Response to Worcester LCWIP

Network consultation

October 2025

Network consultation - Bike Worcester

Route P (Secondary) - Kepax Bridge to Diglis Bridge (Carrington Bridge)

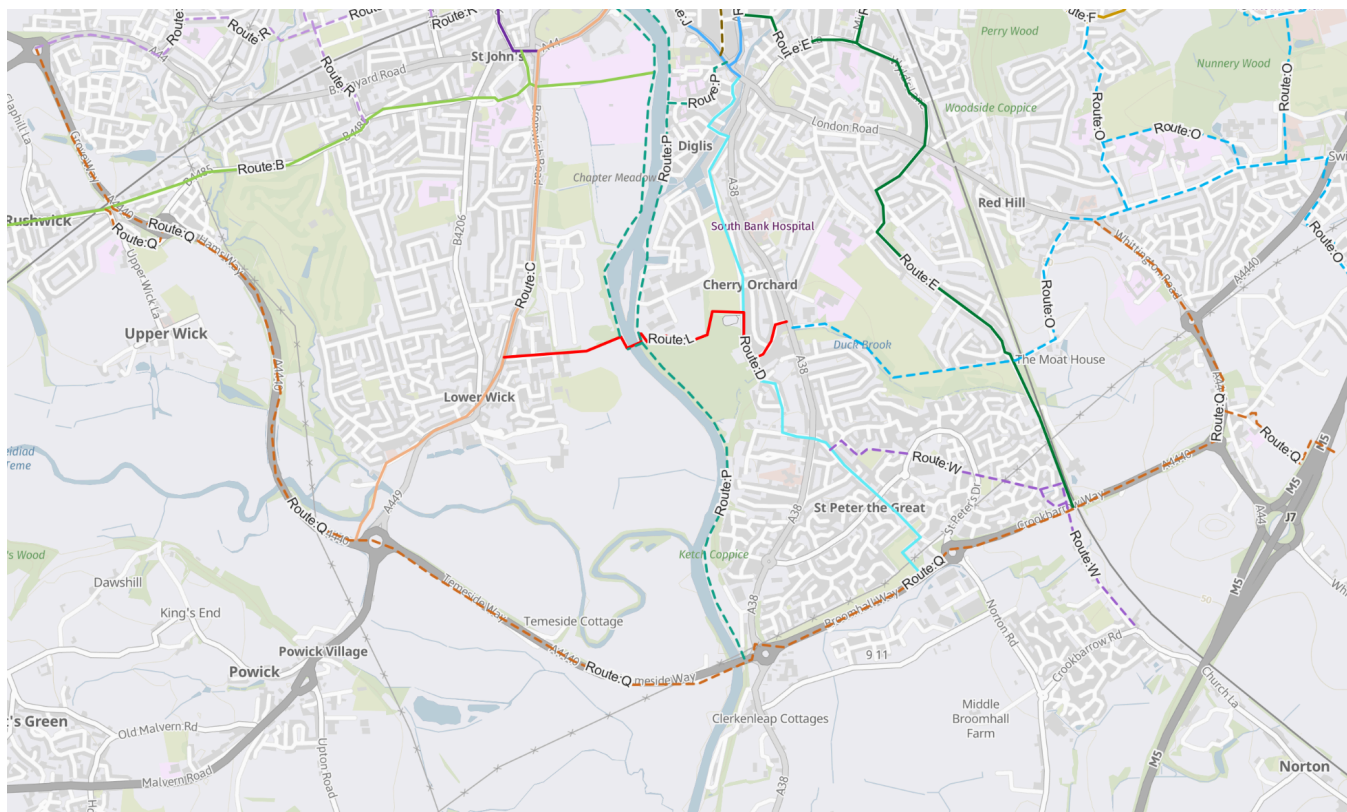
We agree this is needed as a secondary route with improvements in place. The route is already well used by the community.

James N	The Severn Way on the East side of the Kepax Bridge is susceptible to becoming muddy and impassable by bike.
Wilf	Support. There needs to be a decent quality riverside link between Ferry Steps and Keepax.

Route Q (Secondary) - A4440 Southern Link Road

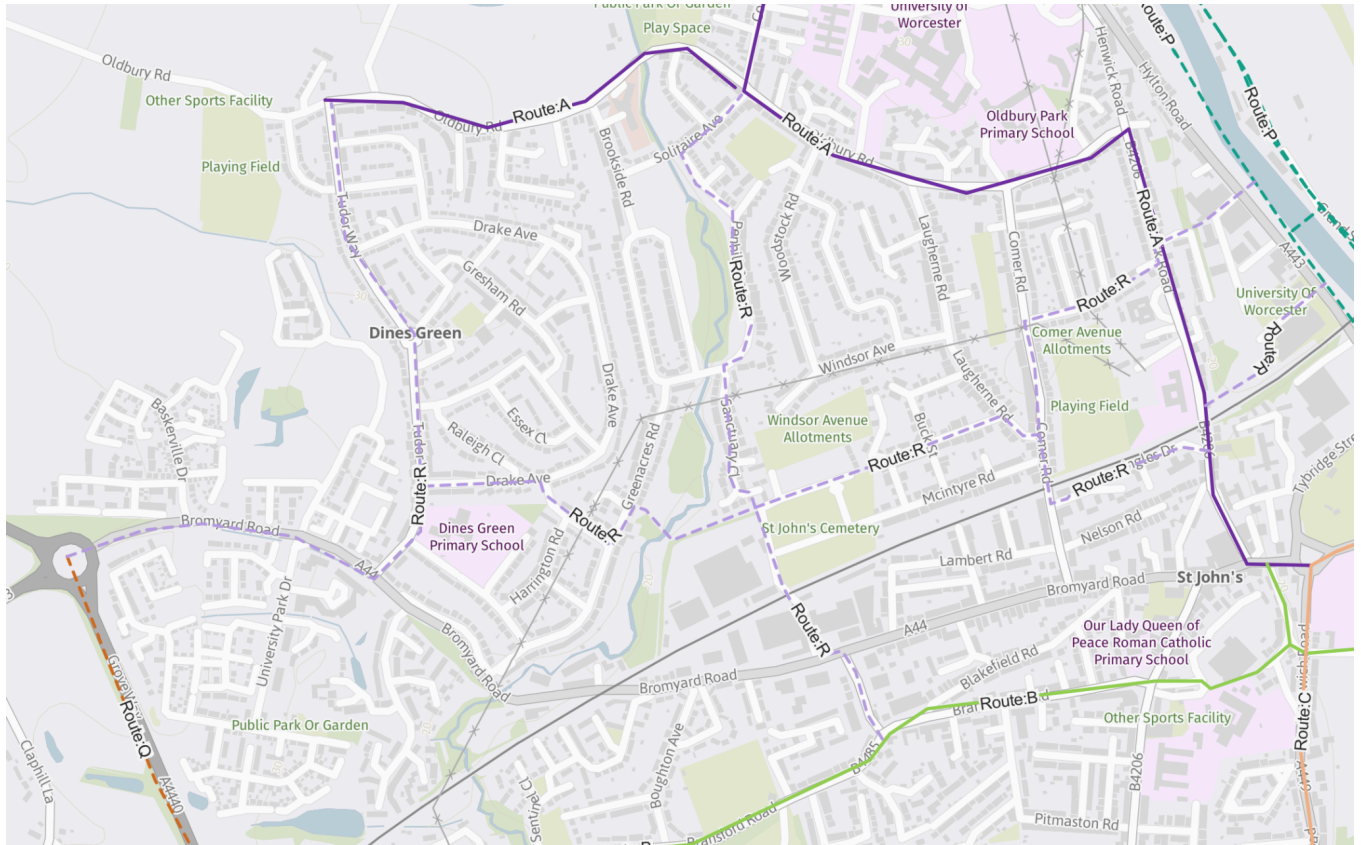
We agree this is needed as a secondary route but do not consider this a priority. The route is already used by the community.

James N	I use this route occasionally to get from Powick Roundabout to St. Peters. Leading up to the Carrington Bridge, the lack of barriers at points makes this route feel quite exposed to the high speed traffic of the road. It is also quite loud and the air quality isn't great. I'm glad we have this route, but it's not a particularly pleasant one to ride on.
---------	--

Route R (Secondary) - Dines Green and St John's links

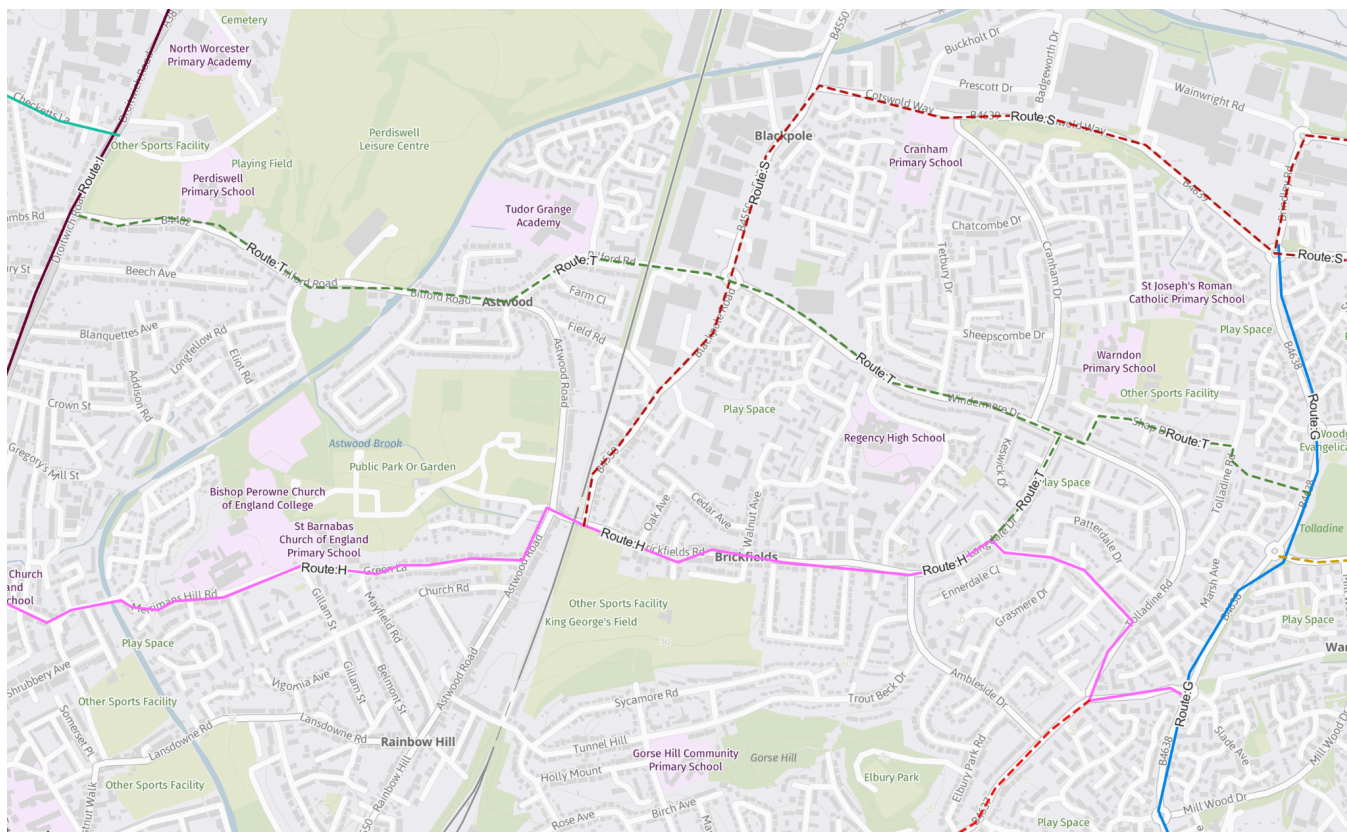
We think this should be a primary route with certain improvements in place. This route links multiple future housing developments to the city centre. We think there should be more consideration for onward links.

Wilf	Support. However, there needs to be an additional route along Happylands Walk/Lambert Road/Nelson Road as the nearest parallel route on the north side of Bromyard Road. Need improved crossing of Bromyard Road at Watery Lane. McIntyre Road/St Johns Cemetery is a good daytime route. Whilst Bromyard Rd is tricky towards the Bull Ring, it is still a direct route to Worcester Bridge, and should not be abandoned as contributing to active travel; between Watery Lane and Sentinel Close there is width to provide cycle facilities - a valuable E-W/N-S crossing point of Bromyard Road, particularly given the new housing across the west of the city boundary. Westbourne Close should be shared pedestrian/cycle route. The unnamed lane between Fenwick Road and St Clements gardens should be a shared route along its length, extending Nelson Road to the east. The zebra crossing at Hilton Road by the Arena needs to be upgraded to accommodate cycles.

Fleur	Route P-R-A: For going from Sabrina bridge to the University it is unpleasant having to take route R along the Elizabeth Garrett Anderson building or along Hollywell Hill. These paths are too steep (especially when carrying child). It is much more convenient to go along Hylton Rd to Henwick Rd and take the Severn entrance. However the section of Hylton Rd. just after Hollywell Hill seems to narrow slightly, while cars still try to overtake at high speed. So this nw direction requires a big detour for some unless Hylton Rd could be more accessible.

Route T (Secondary) - Barbourne to Warndon

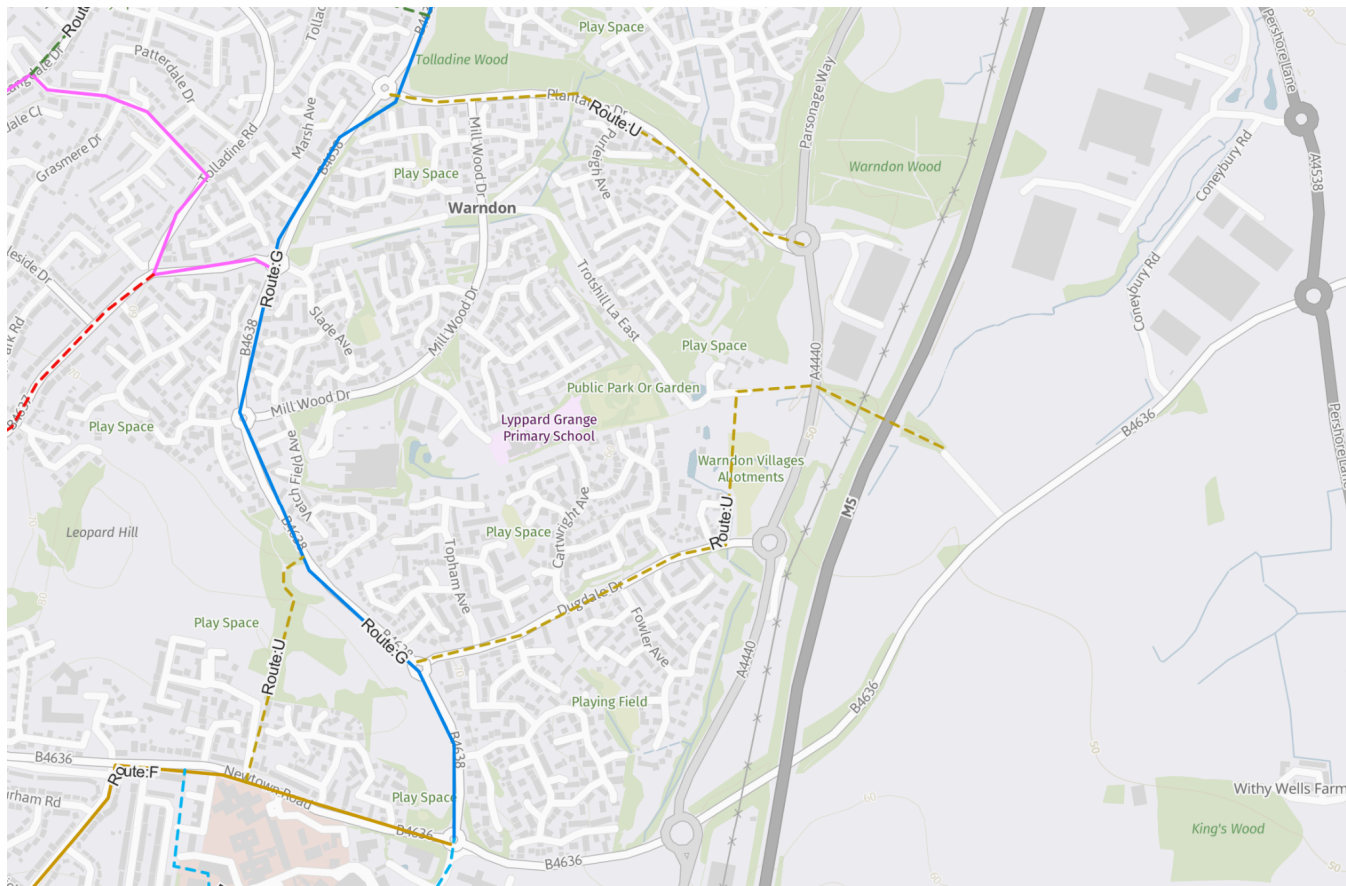
We think this should be a primary route. A good route would be well used by the community.

Ian FW	I support this as a route, but not sure why it's only secondary? There is no safe way to get from North Worcester to Blackpole, or across Worcester to e.g. Worcester Woods, Hospital, or Orbital PedWay. Cutting through Perdi and onto Bilford then up to Windermere is dangerous, and really puts people off, forcing car use to Blackpole for what is really a short journey. Would like to see this given more priority.
--------	---

Route U (Secondary) - Worcestershire Royal Hospital to Worcester Six Business Park

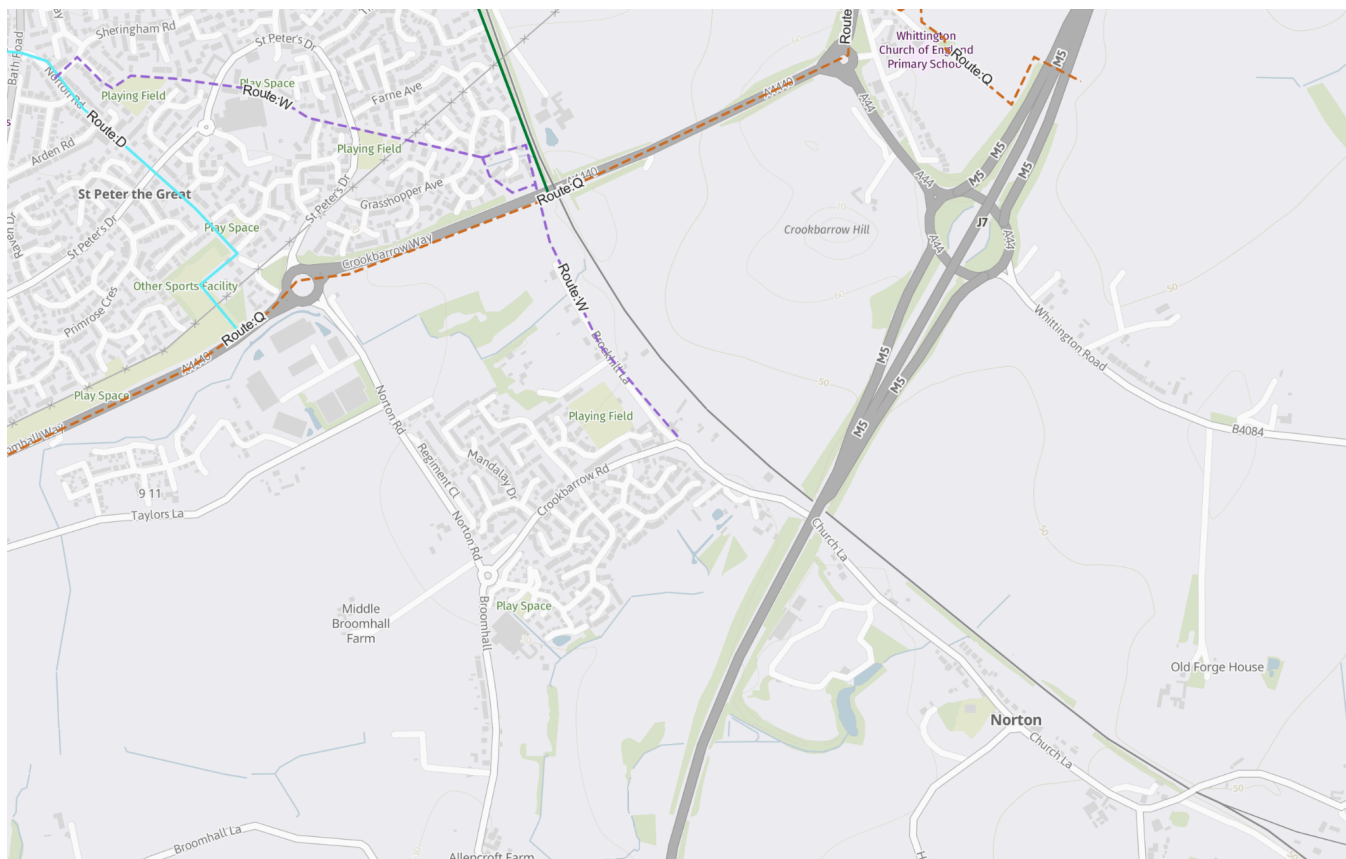
We agree this is needed as a secondary route but do not consider this a priority.
